Project	<b>IEEE 802.16 Broadband Wireless Access Working Group</b> < <a href="http://ieee802.org/16">http://ieee802.org/16</a> >	
Title	<b>Per-Stream Bit Loading for MIMO Precoding</b>	
Date Submitted	<b>2004-11-12</b>	
Source(s)	Qinghua Li, Xintian Eddie Lin, Ada Poon, Nageen Himayat, Minnie Ho, Shilpa Talwar, Sumeet Sandhu <b>Intel Corporation</b>	<a href="mailto:qinghua.li@intel.com">qinghua.li@intel.com</a> Voice: +1-408-765-9698
Re:		
Abstract	Per-Stream Bit Loading for MIMO Precoding	
Purpose	Adoption of proposed changes into P802.16e <del>Crossed out indicates deleted text,</del> <u><a href="#">underlined blue indicates new text change to the Standard</a></u>	
Notice	This document has been prepared to assist IEEE 802.16. It is offered as a basis for discussion and is not binding on the contributing individual(s) or organization(s). The material in this document is subject to change in form and content after further study. The contributor(s) reserve(s) the right to add, amend or withdraw material contained herein.

# Per-Stream Bit Loading for MIMO Precoding Systems

Figure 6 Transmitter structure for MIMO precoding

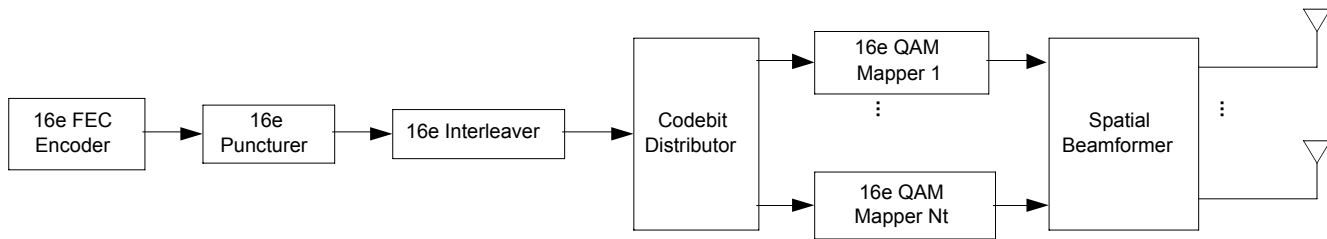
Add section 8.4.8.3.6.1 on page 242 of [1] as follows

#### 8.4.8.3.7 Transmitter structure and bit loading scheme for MIMO Precoding

Transmitter loads the interleaved coded bits to each data stream according to Table 3 and Figure 6.
